# AL572B Updates and Error Corrections

Rev0A 11/3/22 W&JI

Figure 3 (plug-in relays) D116 location

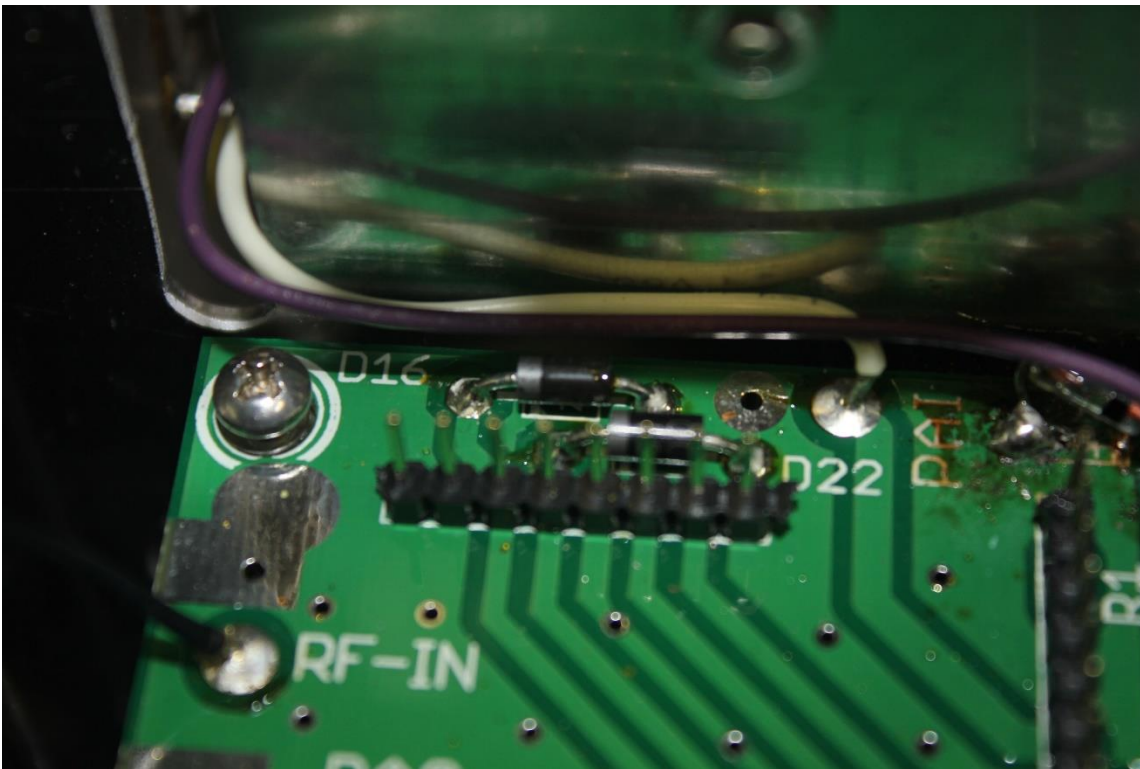
1.) Remove D116 (board omits the leading 1 and says “D16”). D116 needlessly slows input relay return time. D116 is near the center panel rear. Plug-in relay units will need the relay board removed. Just snip either end of D116 with small cutters. There is no reason to remove D116 entirely so long as it is disabled by snipping a lead. D116 is the diode with zero ohms continuity from Q106 emitter to D116 striped end (cathode).

Figure 4 Zener and resistor mod

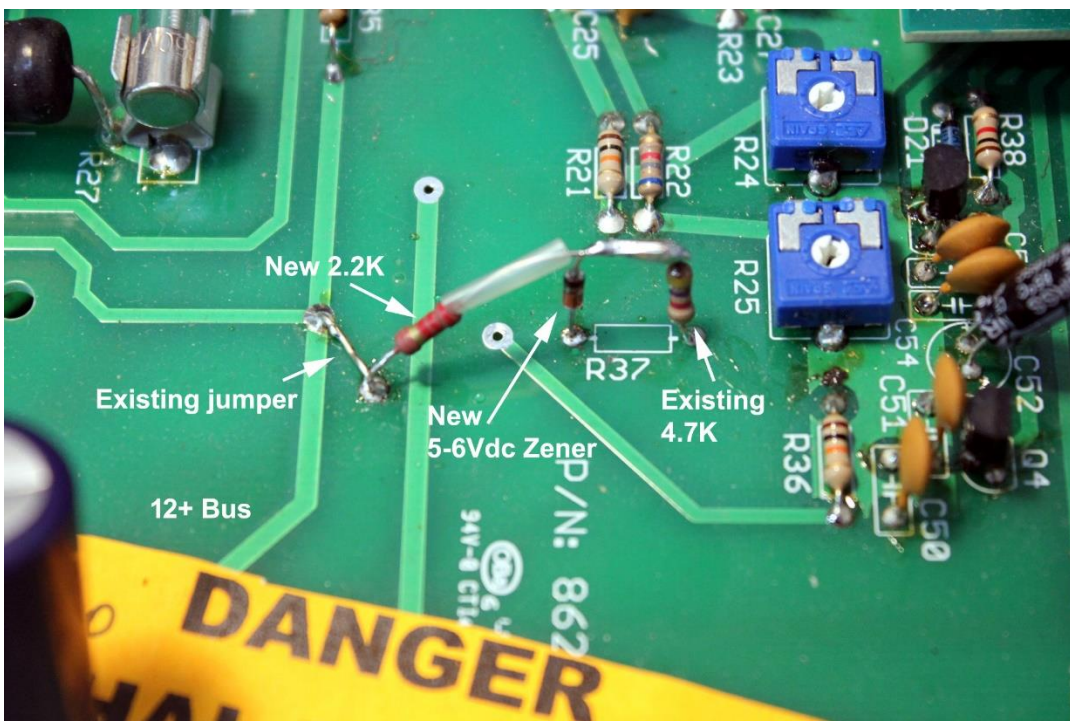
2.) Unsolder and lift the **RLY jack end** of R137 4.7k from the circuit board pad. It is a good idea to first re-wet or reflow that solder connection with regular 60/40 solder. Be careful to not overheat the pad and lift it.

- 3.) Referring to figure 4, the new Zener connects banded end up to the end of the 4.7k lifted in step 1. This makes the threshold voltage on the relay control jack more reasonable at normal logic levels.
- 4.) A new 2.2K resistor bridges from the ~12Vdc control line voltage bus to the junction of the Zener banded end and the lifted end of R137. This resistor reduces the relay control line impedance to a more reasonable level of a few thousand ohms, making receive return more consistent.
- 5.) Radial lead 10uF C152 (sometimes listed in parts as C153 while labeled C52) needs removed and replaced with a .33uF to .47uF capacitor. This capacitor causes the big transmit timing problem in dual relay amplifiers.

Figure 6 modified schematic

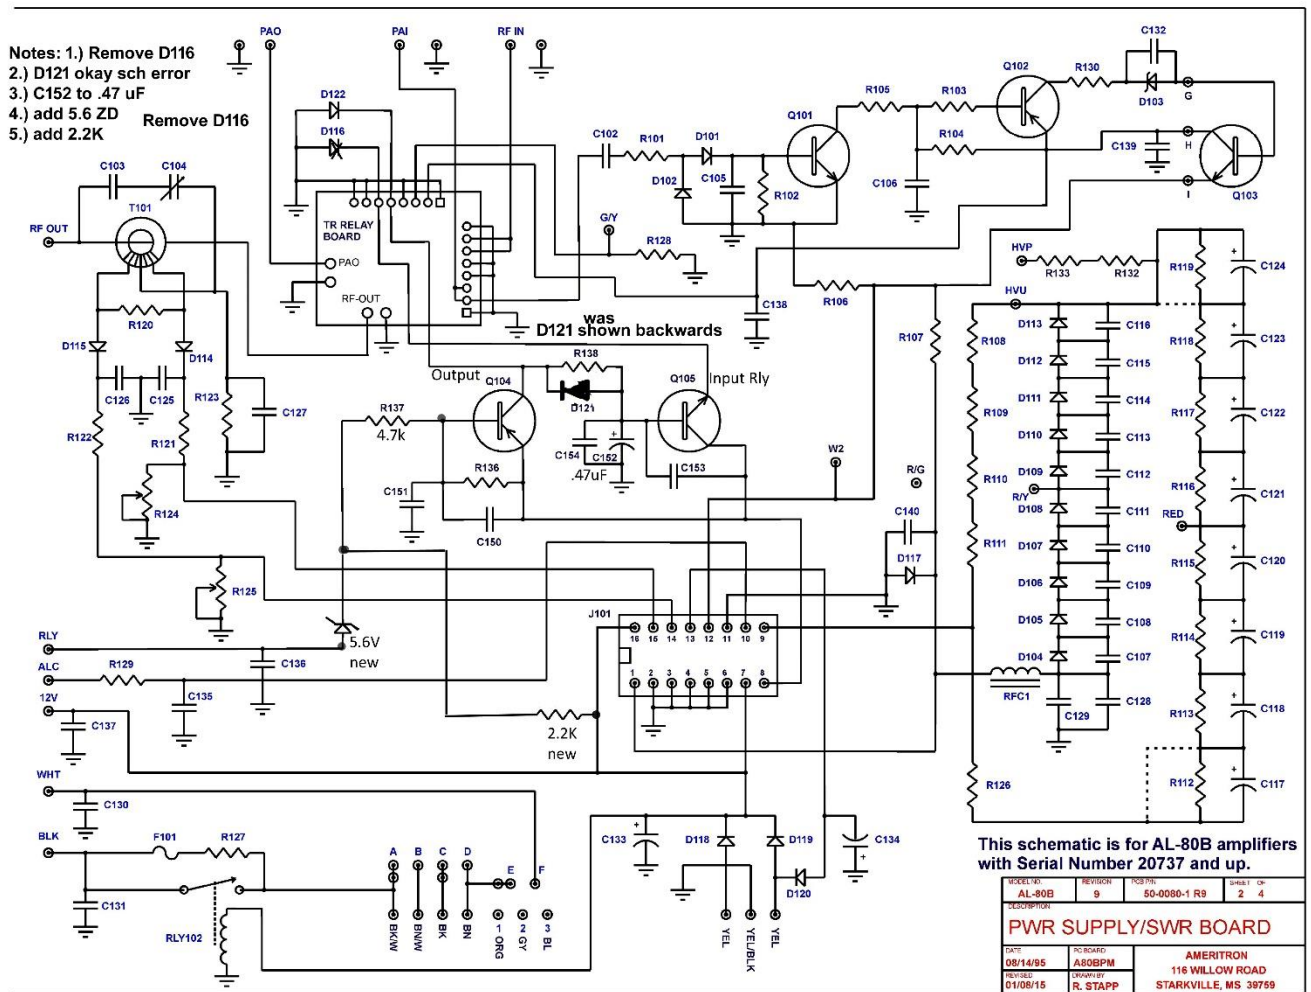
The reworked relay system now looks like this (note that D121 is drawn backwards in some or all MFJ schematics, although D121 is the correct direction as mounted in the circuit board):

The relay system with these simple mods is now about 6mS receive-to-transmit turn over time. Any exciter TX delay setting beyond 7mS will be more than enough.

Figure 7 bias system mods

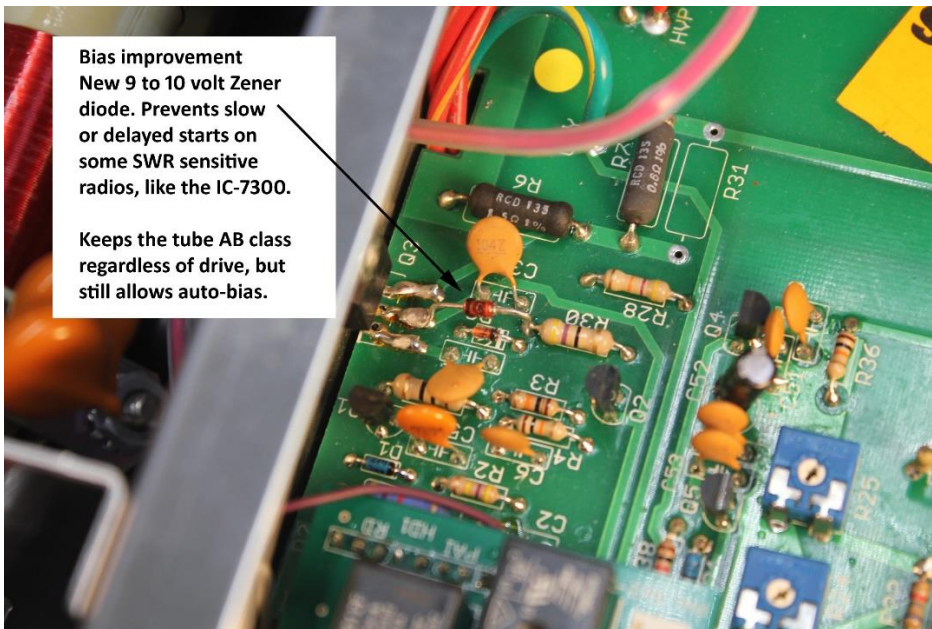
- 1.) Add 9.6V Zener diode from either side of R130 to collector (middle terminal) of Q103, banded end to Q103. The Zener can sit up in the air a little.

Figure 9 PS schematic corrected

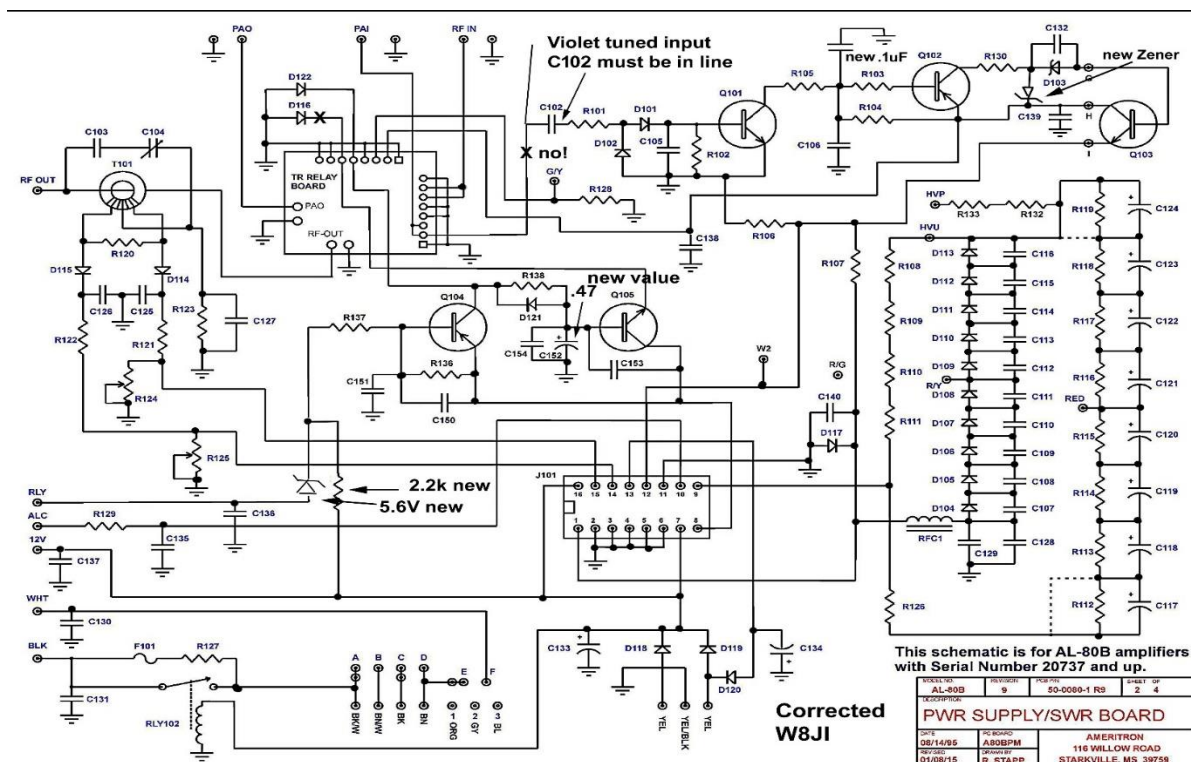
The electronic bias system in the AL8B frame amplifiers went through one authorized change very early in production. This change was relocating the sample point from the T/R relay tuned input contact to the output side of the tuned input. This was accomplished by adding a violet jumper wire directly from the input switch wafer to C102. I have never seen this corrected in schematics, but this correction must be made.

Figure 10 removed grid bypasses and resistors

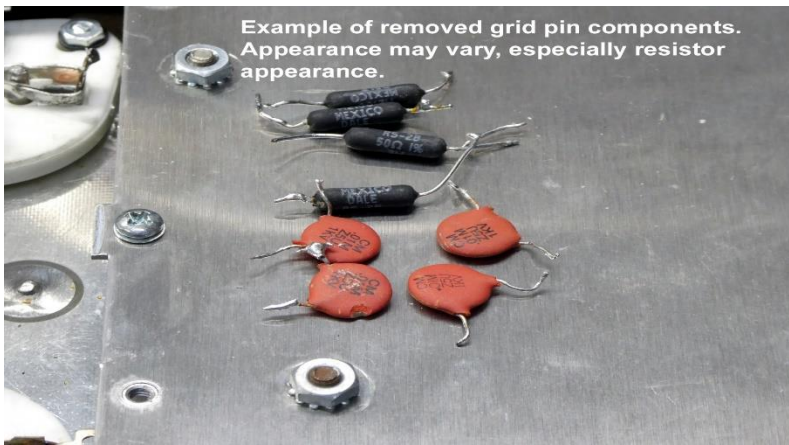
1. Remove old resistors and capacitors from all grid pins. Clean up any bad soldering and tighten all screws.

Figure 11 grid mods AL572

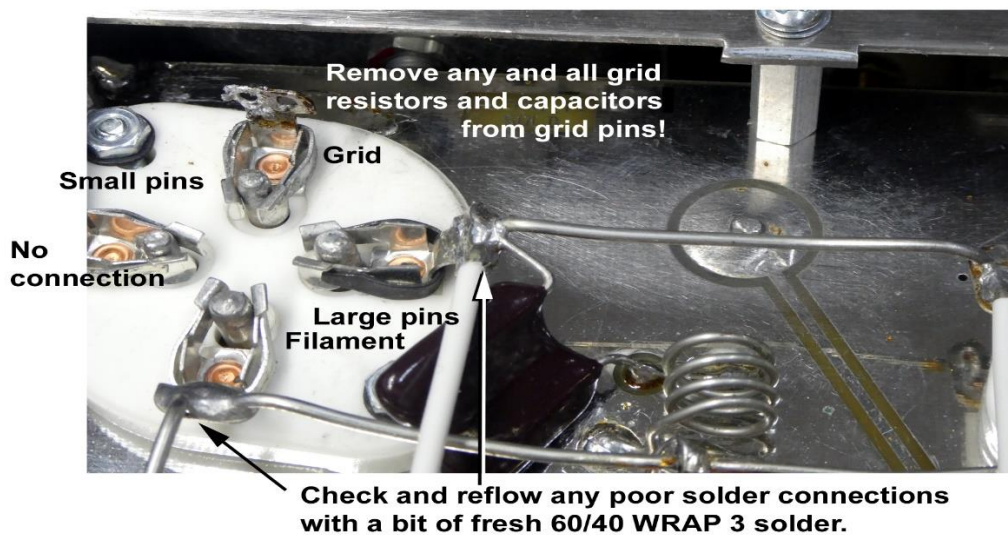
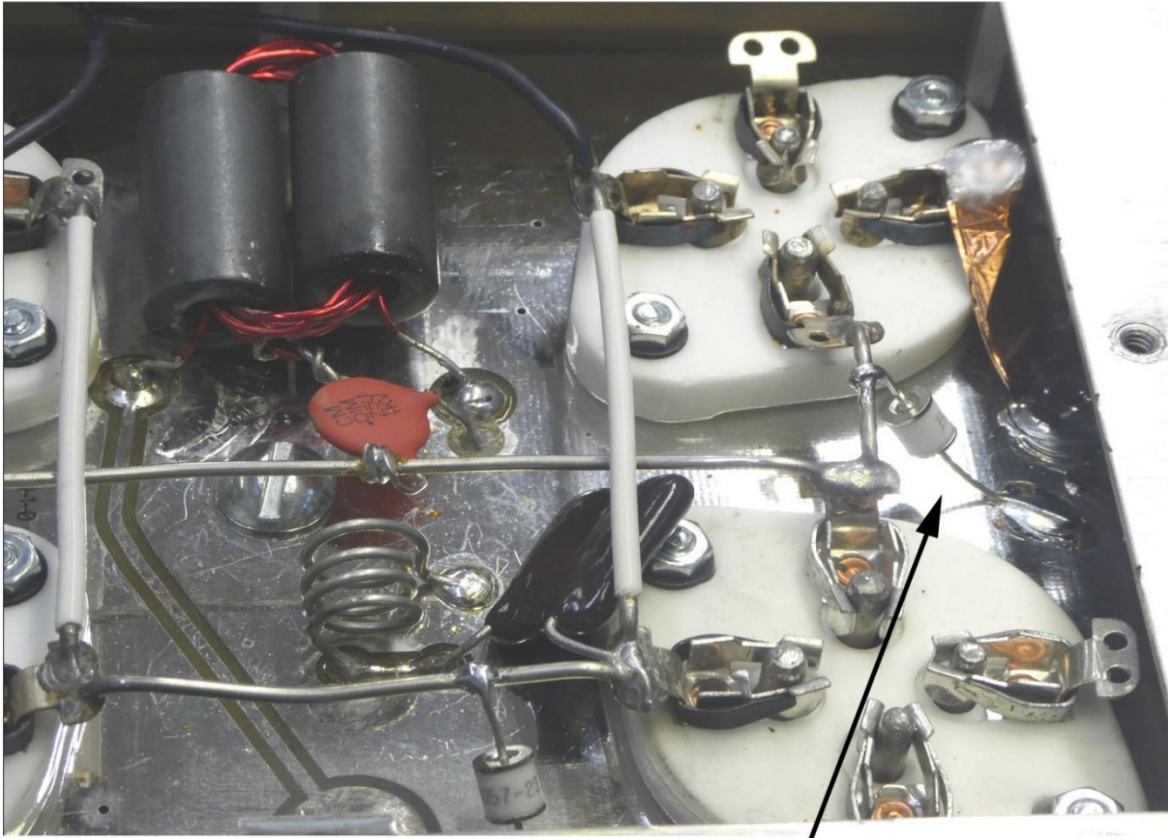
2. Add foil, braiding, or at least #18 stranded wire directly from grid pin to printed circuit chassis ground plane.
3. Add two GDT's, one from each side of filament system anywhere convenient, to ground plane of board.

**Ground each grid pin to the circuit board with a short length of copper foil, braiding, or #14-18 AWG stranded wire**

**Add GDT from each filament side to backplane foil.**
